ADDENDUM #1

Re: Harrisburg Area Community College
Goodling Building Classrooms & Computer Lab Renovations
Solicitation # 11-19

From: Eastern PCM, LLC
Construction Manager – HACC
645 N. 12th Street, Suite 200
Lemoyne, PA 17043

1 ENLARGED PLAN - COMPUTER LABS
SCALE: N.T.S

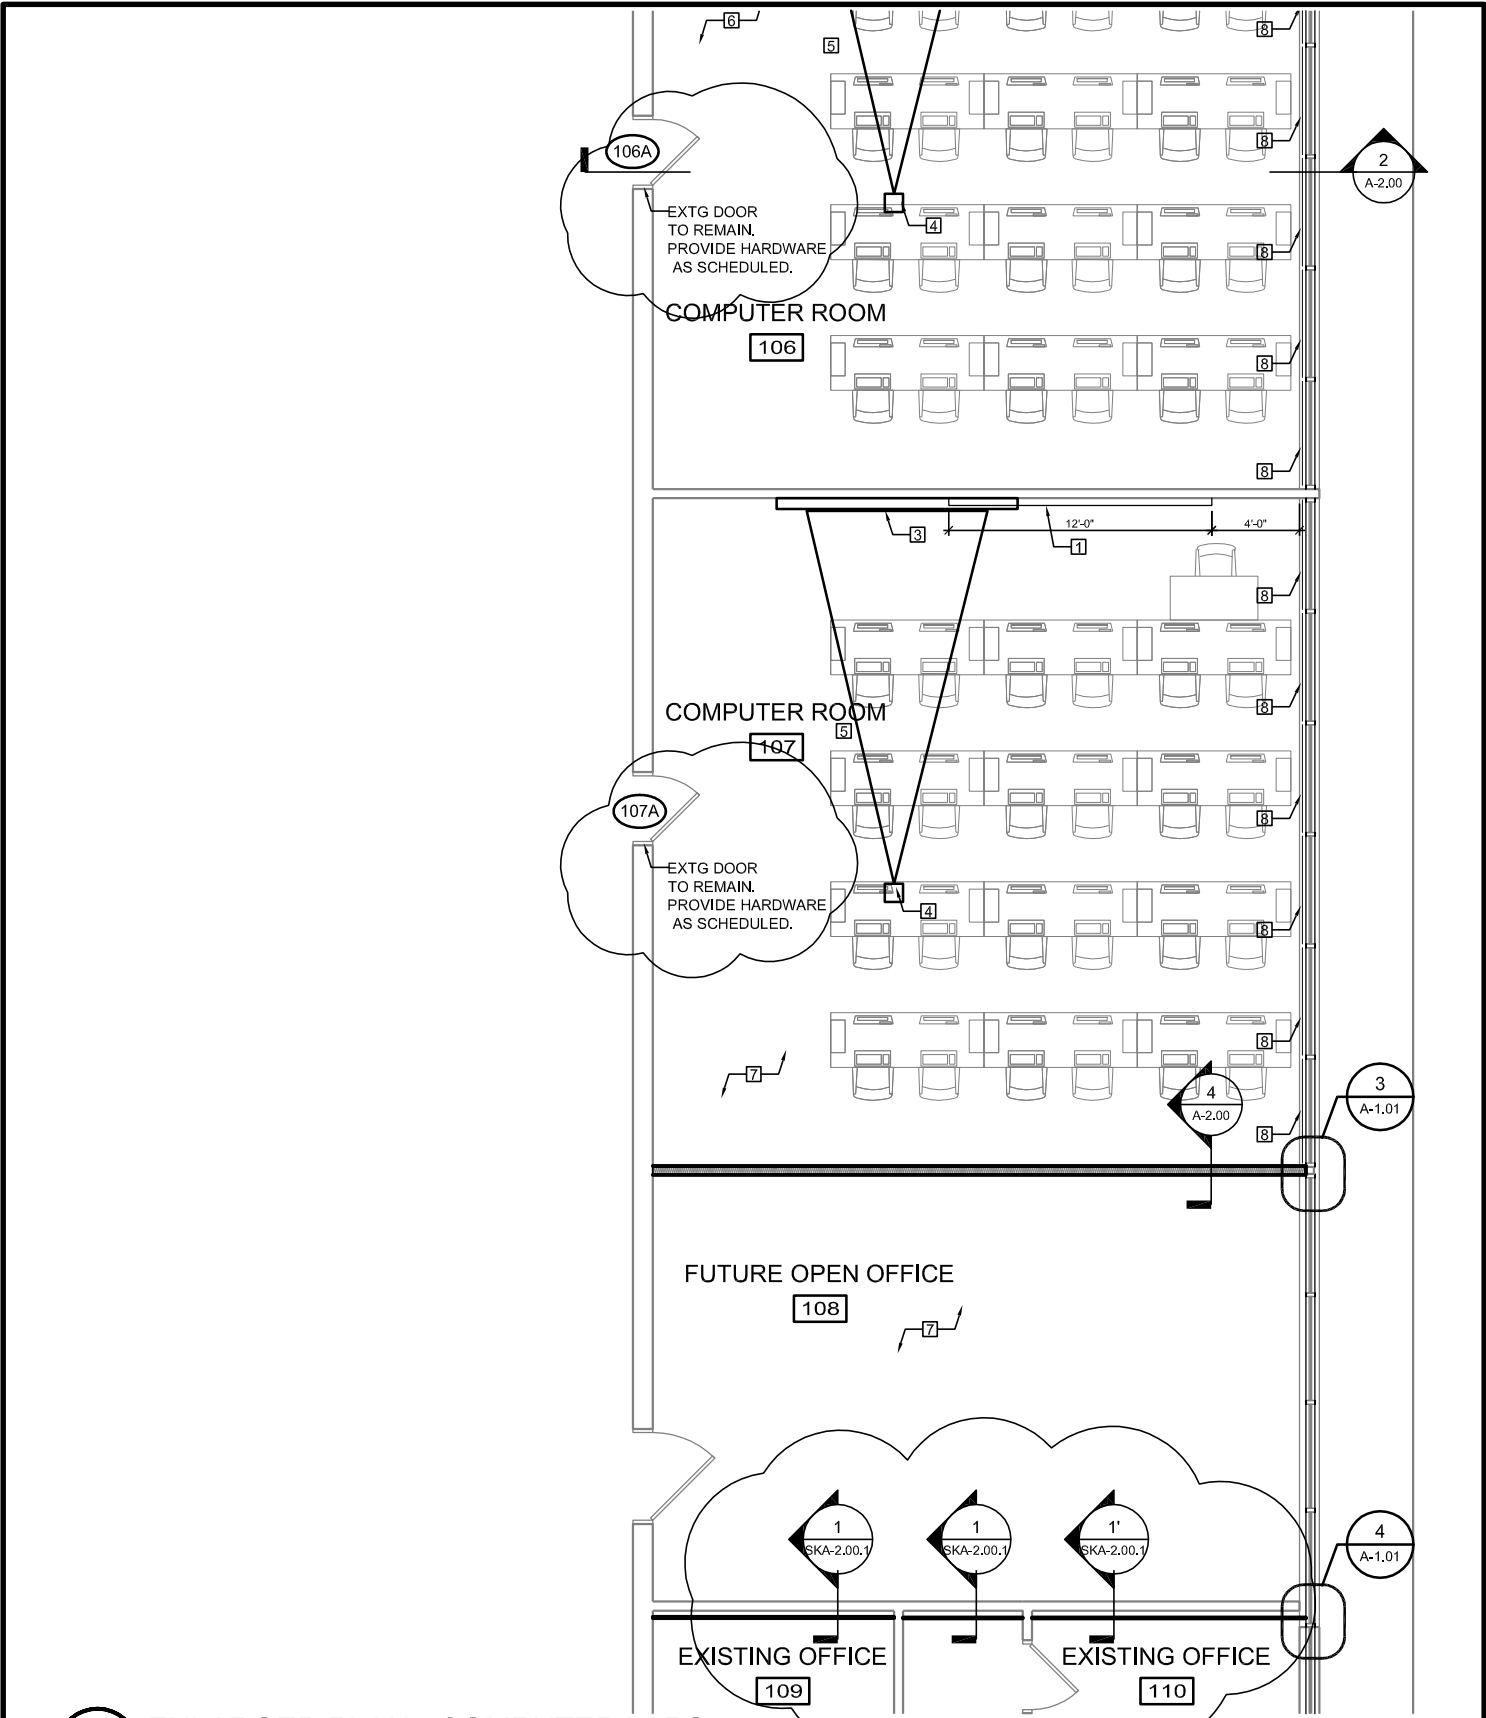
A. Drawing A1.01 – Enlarged Floor Plan

REVISE as follows:

- a. Designate the separated space west of Computer Room 107 as Future Open Office 108
- b. Designate the separated space west and toward the northern corner of Future Open Office 108 as Existing Office 109
- c. Designate the separated space west and toward the southern corner of Future Open Office 108 as Existing Office 110
- d. Add wall section flag thru improved east wall of Existing Office 109 designated 1 and refer to attached Sketch skA-2.00.1 for its construction.
- e. Add wall section flag thru improved east wall of Existing Office 110 designated 1' and refer to attached Sketch skA-2.00.1 for its construction.
- f. Expand Note 4 concerning the drop post projector mount. "HACC will furnish the mounting assembly (in accordance with the product data attached to this Addendum) for installation and connection by the Contractor."

DATA PLAN
SCALE: 1/8" = 1'-0"

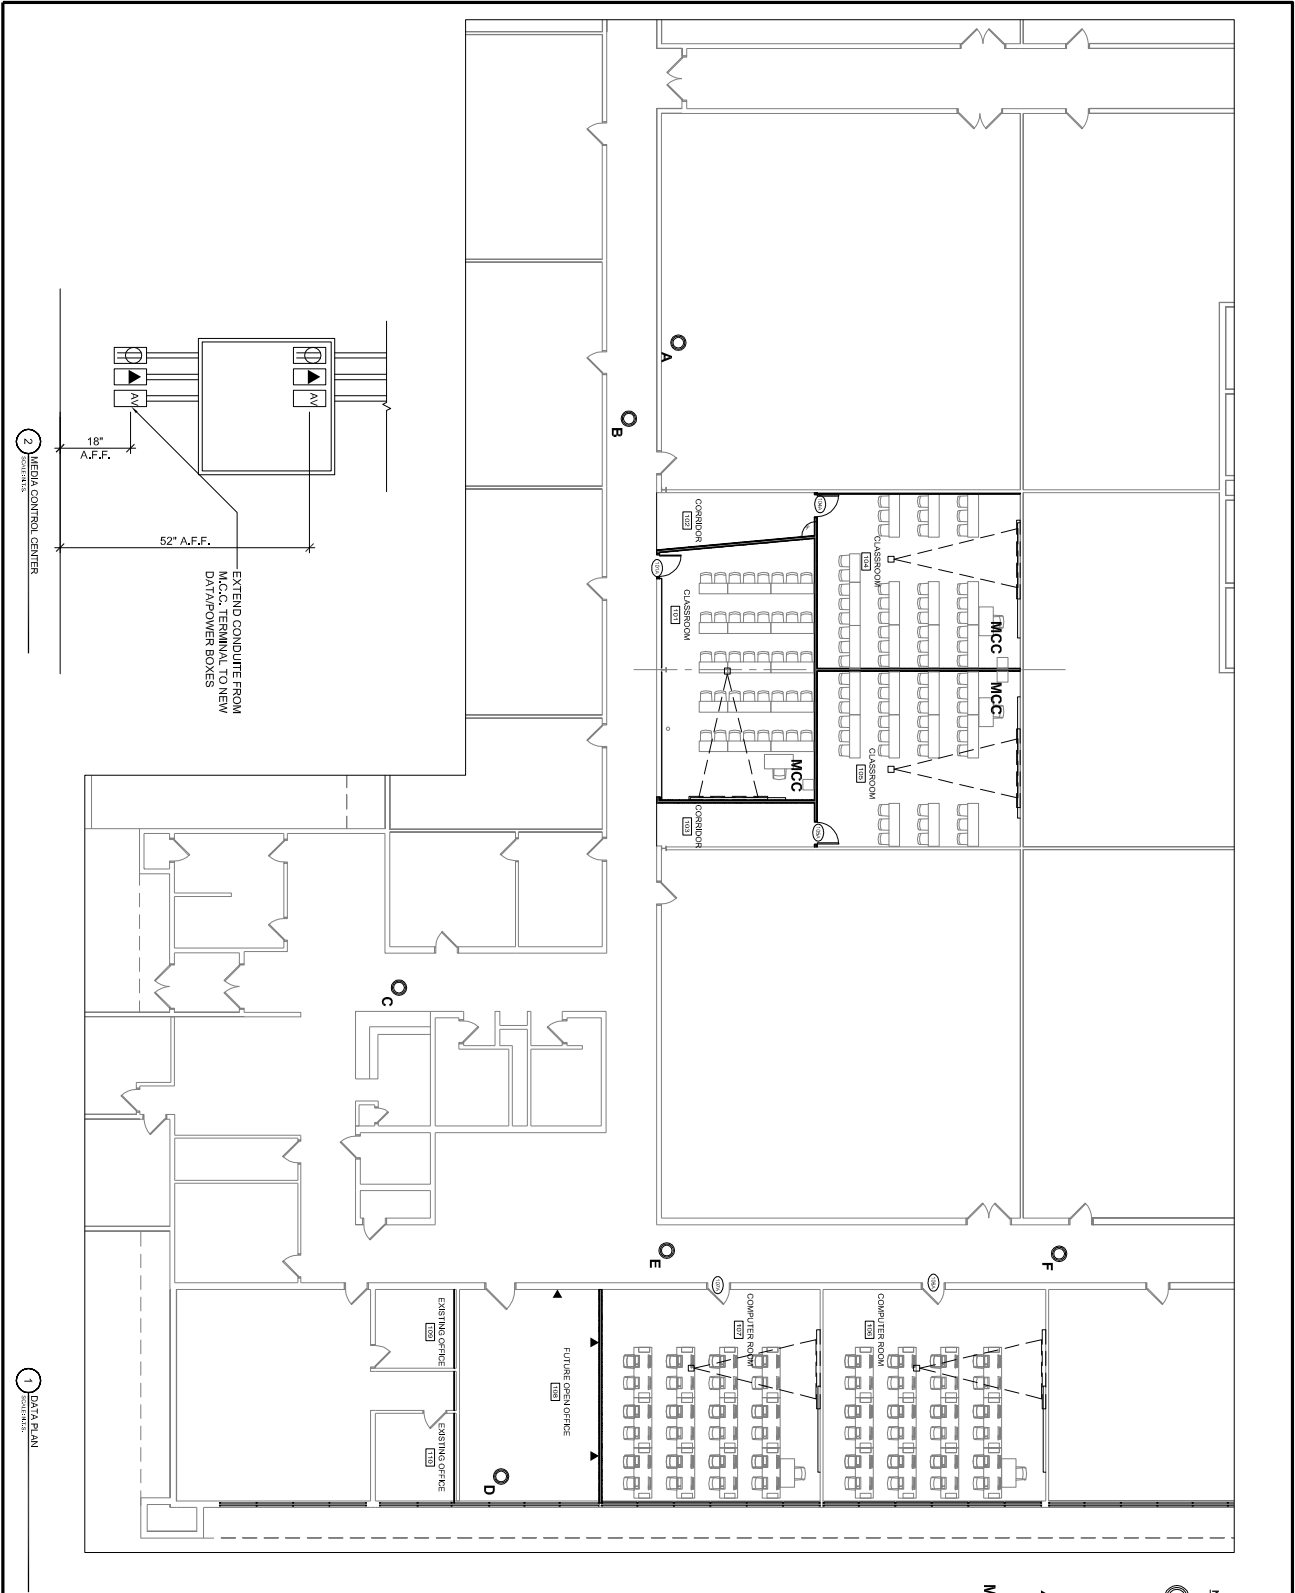
D. Drawing D-1.00 – Data Plan

ADD Drawing D-1.00 – Data Plan, Attached

- PULL DATA CABLE AND COIL ABOVE CEILING, INSTALL ENDS & TEST
 - A: 20' COIL - 13 RIMS
 - B: 20' COIL - 7 RIMS
 - C: 20' COIL - 4 RIMS
 - D: 20' COIL - 2 RIMS
 - E: 20' COIL - 4 RIMS
 - F: 20' COIL - 4 RIMS
- ▲ DUAL DATA JACK LOCATIONS (SUPPLEMENTAL TO DRAWINGS E-1.2) LOCATE IN WALL @ 18" A.F.F.
- MCC MEDIA CONTROL CENTER
